DEVELOPMENT REVIEW BOARD REPORT

CASE NUMBER/ **27-DR-2005**

Body Sculpting Center

REQUEST Request approval of a site plan, landscape plan, and elevations for an expansion

NEW SITE PLAN

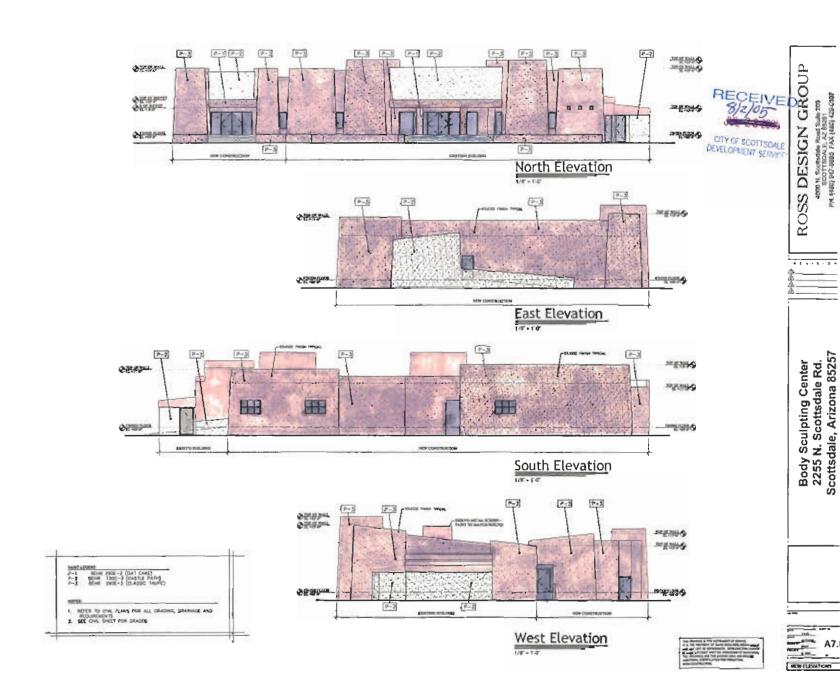
- 26. The conceptual drainage report is not approved due to the following deficiencies:
 - a. Underground storage as shown on the Preliminary Grading and Drainage Plan is not allowed.

- b. Infiltration of stormwater through the basin floor is not acceptable as the sole means of draining the basin. Basin bleed-off rates shall be set so that the storage basins do not drain completely in less than 24 hours. Storage basins must drain completely within 36 hours.

- c. Drywells are not permitted.
 - d. Retention basin shall be constructed with a gravity bleed off system that conveys stormwater to the alleyway. Drainage from the roof shall be designed to convey to the retention basin as much as possible.

- e. Drainage report and Grading and Drainage Plan shall be revised to address the deficiencies. With the final improvement plans submittal, the developer shall submit two (2) hard copies and one (1) compact disc copy of the complete final drainage report and plan.
